CITY OF SANTA ANA

Application Description: Expanding existing unit 500 into 550 & 555: Adding demising walls, locker rooms, add non-bearing partitions, realign ceiling and mechanical systems

TENANT IMPROVEMENT PLAN CHECK COMMENTS

PLAN CHECK NO:	10173124	
PROJECT ADDRESS:	200 W Santa Ana Blvd Unit# 500	
PLAN CHECK ENGINEER:	Mazarji, Zac	TEL: 714 647-5831
		FAX: 714 647-5897
TYPE OF CONSTRUCTION:	I A, SPK	
OCCUPANCY CLASSIFICATION(S):	B	
PLAN CHECK DATES:		REMARKS/RECHECK ITEMS:
APPLICATION	9/6/2011	
INITIAL REVIEW	9/7/2011	
EXPIRATION	3/4/2012	
RECHECKS:	1. 2. 3.	PROJECT APPLICANT CONTACT PERSON: Fraser McClellan
VALUATION:	\$300,000.00	TEL: (714)897-3382
FLOOD ZONE:	X-0602320276J	FAX: (714)897-5952
		EMAIL: Fraser@FMAcorp.com

Fifth Floor Exterior Emergency Exit Plan (Parking Structure Deck)

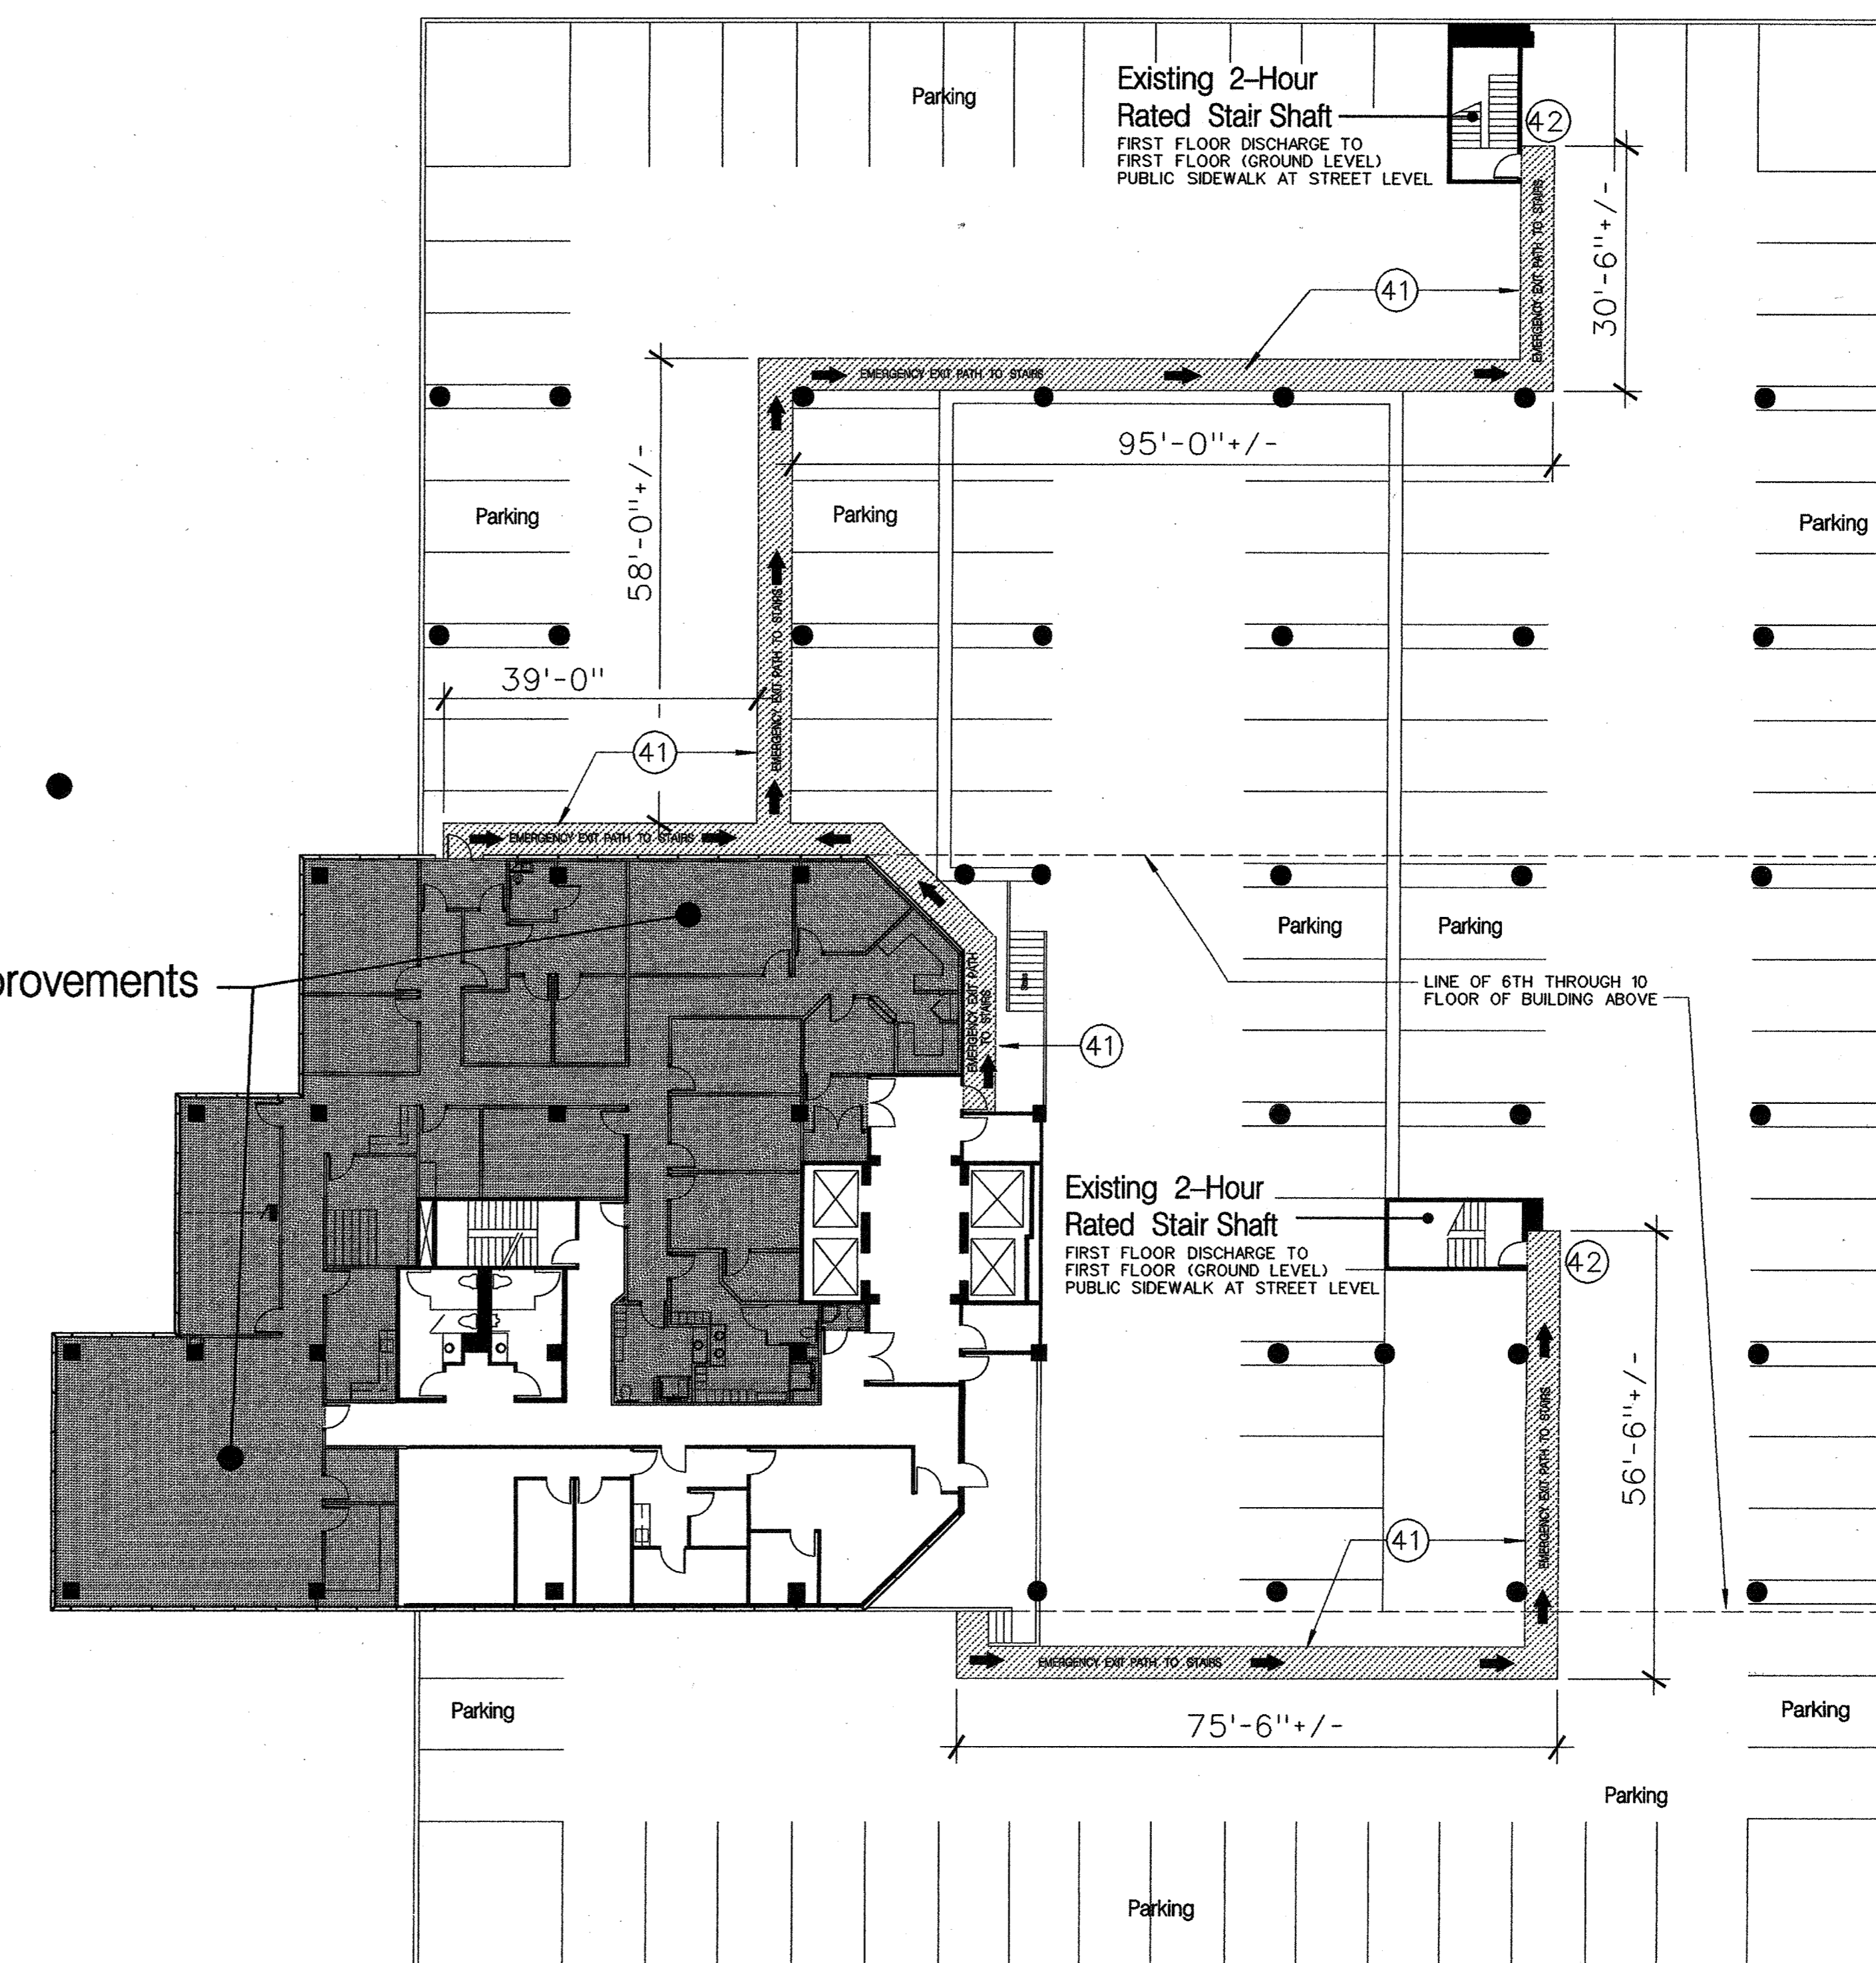
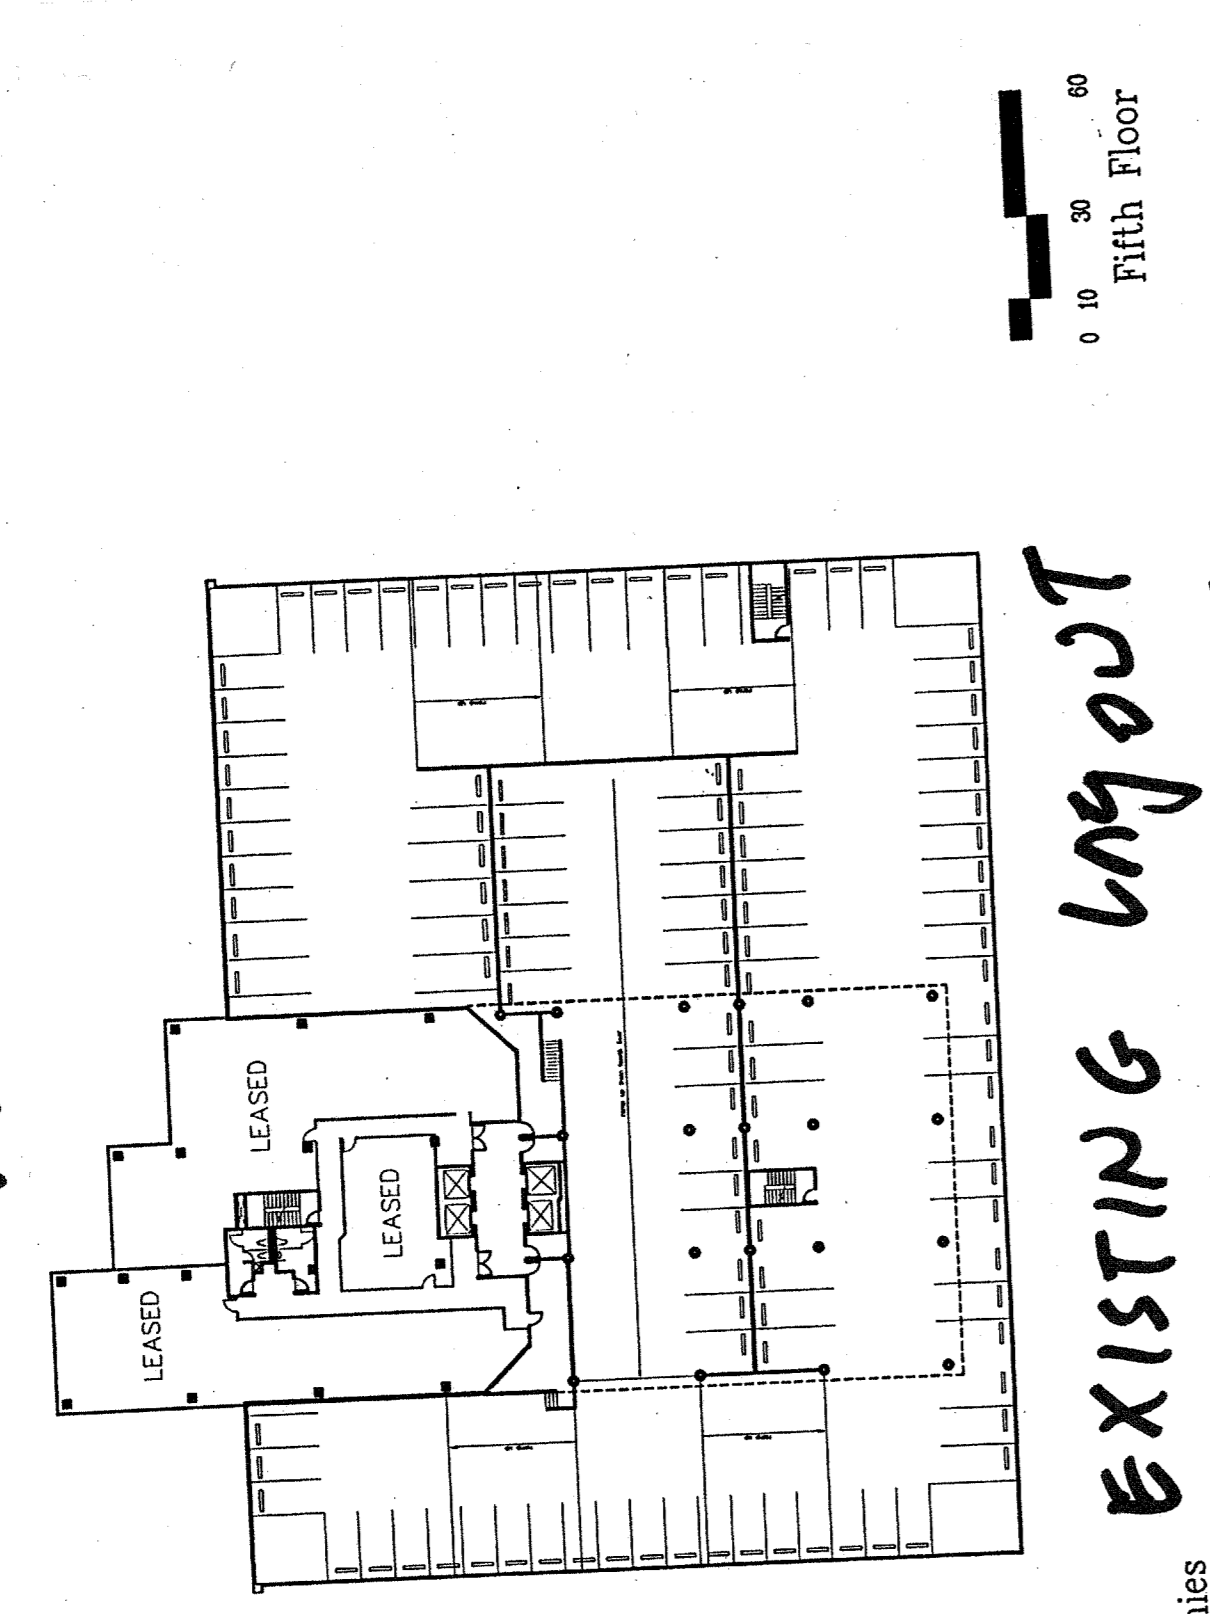
12. Show location of two stairway enclosures for existing floor. Revise door schedule to show 90 minute doors and provide number of exits required by CBC Sections 1015, 1016 and CBC Section 1019.1. Minimum of two exit enclosure is required for this floor. *EXISTING BUILDING, PATH TO TWO OUTSIDE STAIRWELLS TO BE MARKED WITH PAINT SIGNING ON CONC. ALTERNATE MEANS.*

? 16. Existing through parking garage is not permitted. Revise location of exit signs. An exit shall not be used for any purpose that interferes with its function as a means of egress. Once a given level of exit protection is achieved, such level of protection shall not be reduced until arrival at the exit discharge. Sections 1018 through 1023 and the applicable requirements of Sections 1003 through 1013. *EXISTING CONDITION*

- (41) PROVIDE NEW 48" WIDE, YELLOW 4" WIDE STRIPED, PAINTED EXIT PATH WITH DIAGONAL STRIPING AT 24" O.C. PROVIDE 12" HIGH PAINTED BLOCK LETTERS "EMERGENCY EXIT PATH TO STAIRS" AND PAINT 12" HIGH RED ARROWS PAINTED WHERE INDICATED ON KEY PLAN / EXIT PATH PLAN ON THIS SHEET.
- (42) MAKE REPAIRS TO WALL MOUNTED EXIT SIGNAGE AT THIS LOCATION

Fifth Floor Reflected Ceiling Plan

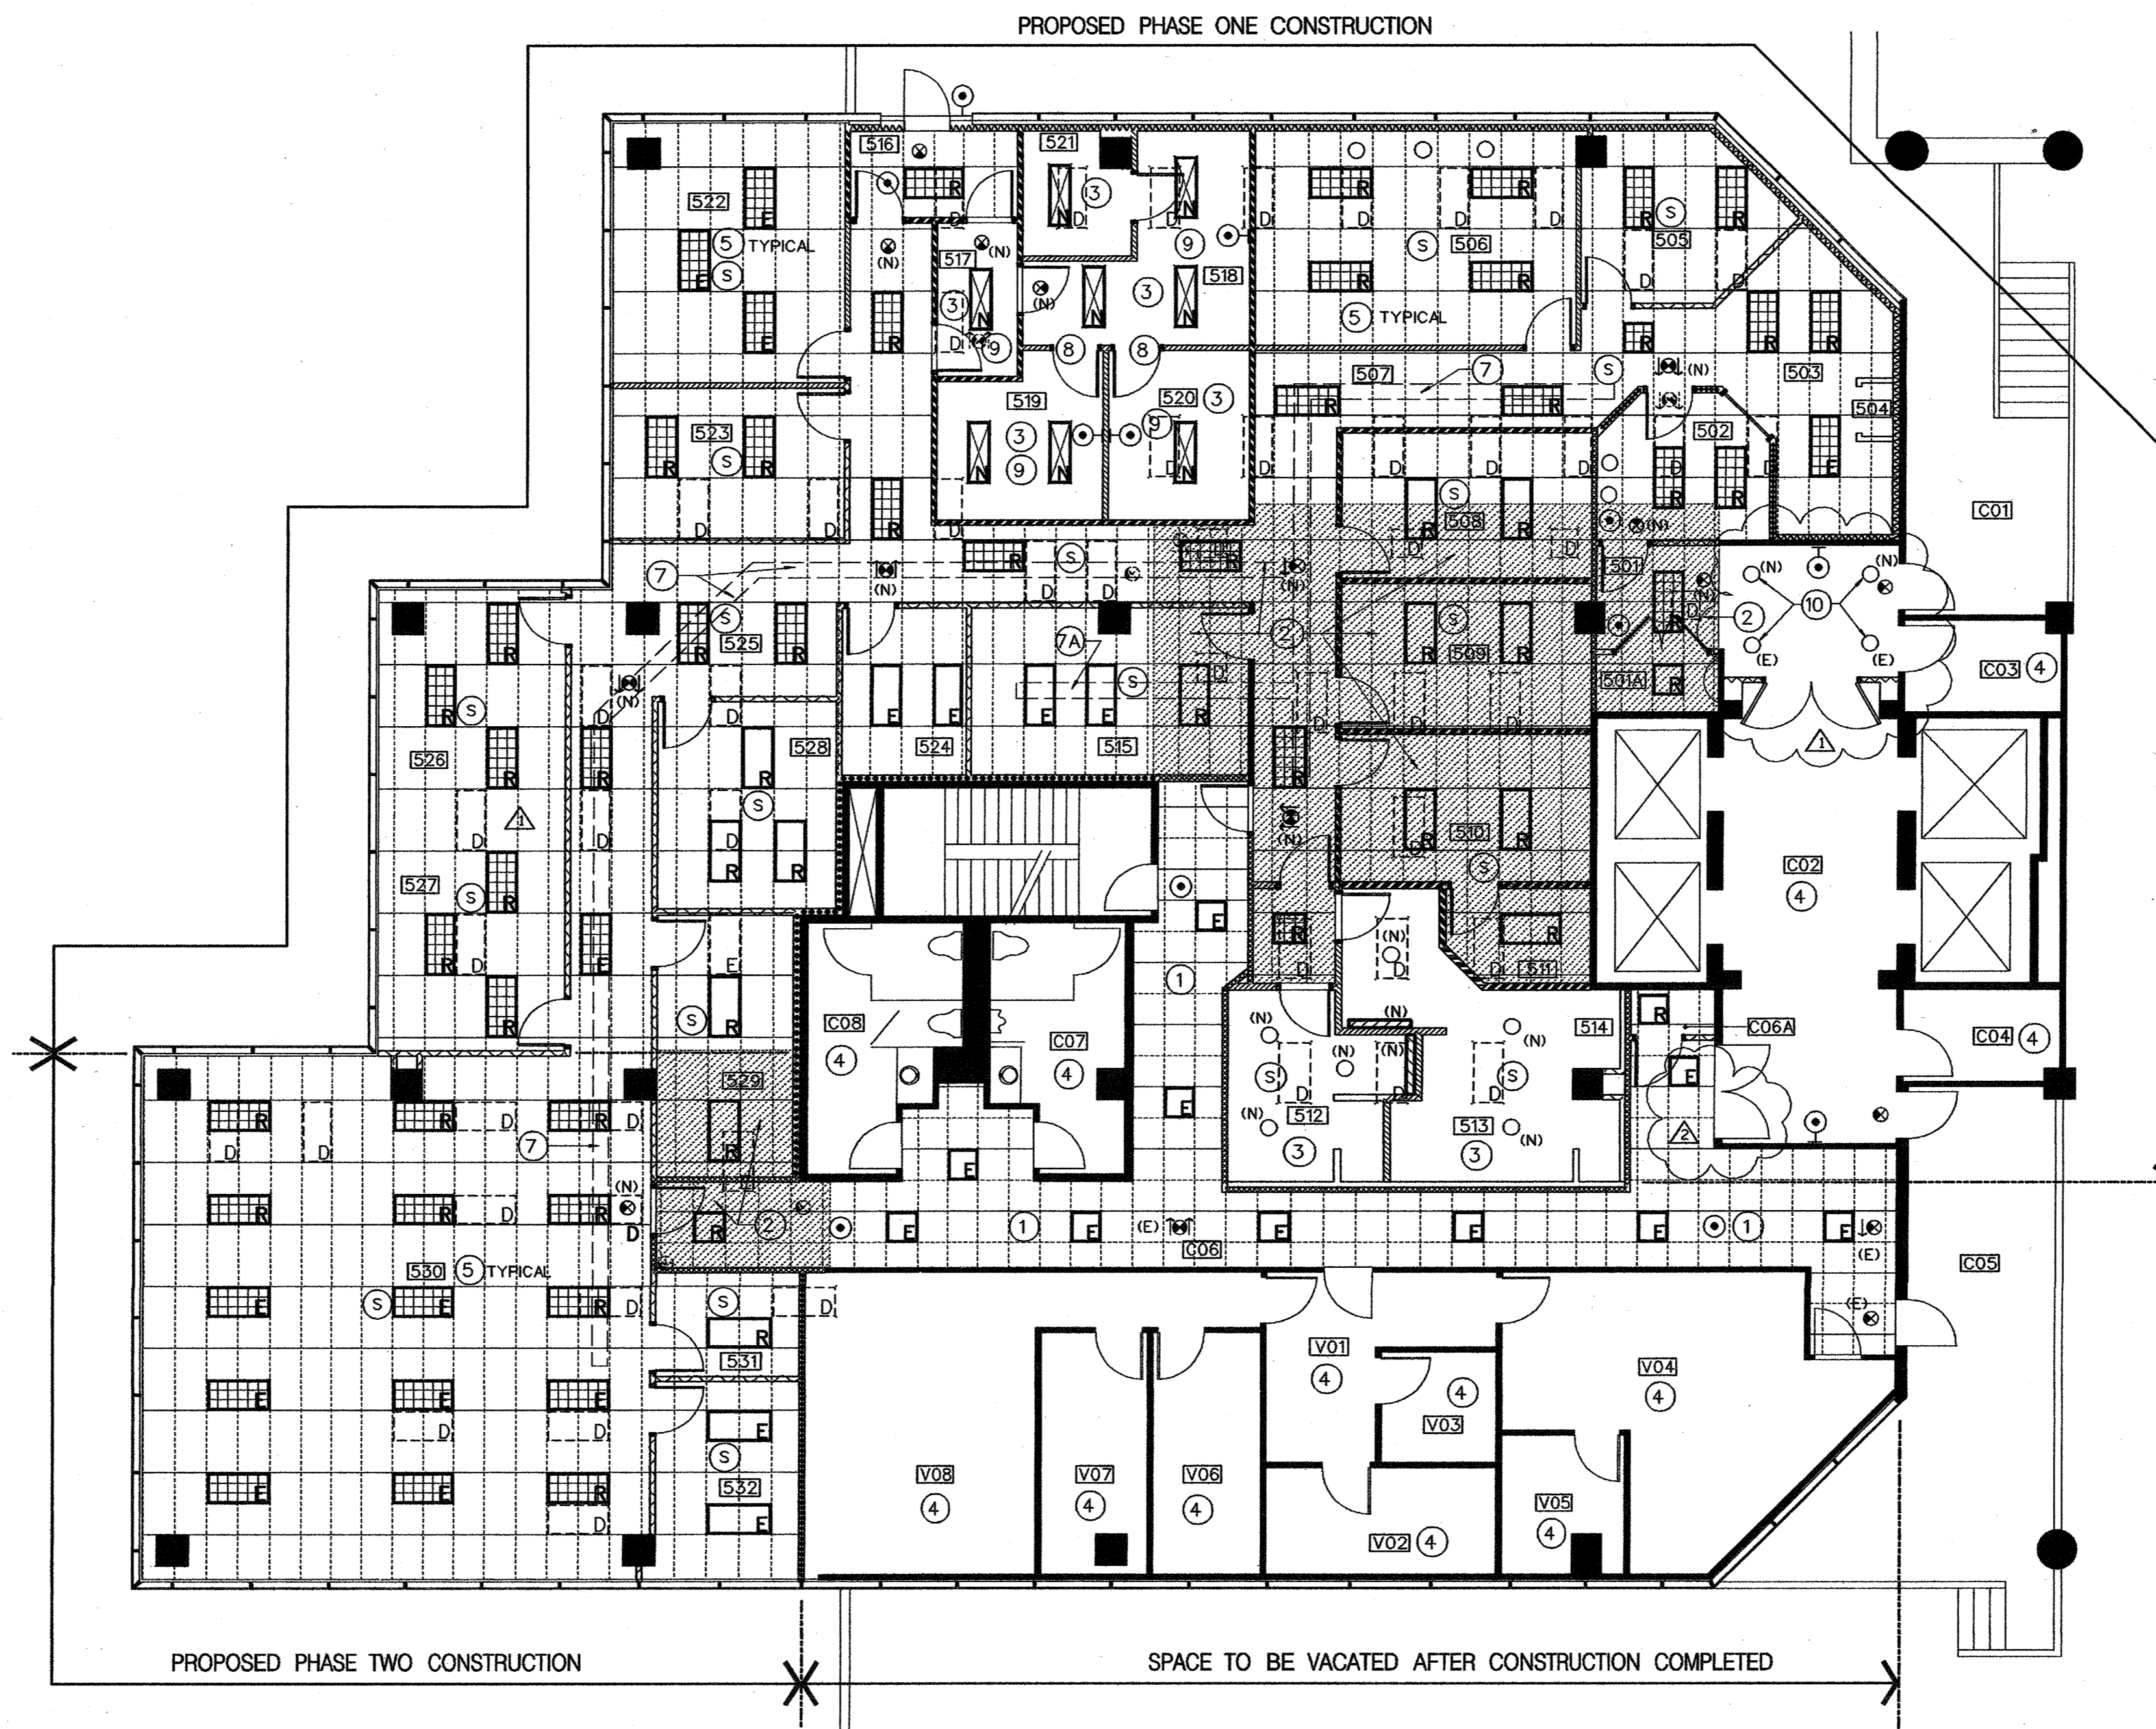
51. Note ICC Research Report Number on the drawings for the suspended ceiling system. (ICC Report Number 1308) *NOTE ADDED ON A-3 AND DETAIL E/AD-1*

THE CEILING SHALL BE HEAVY DUTY, DESIGNED PER ICC-ES ESR 1308
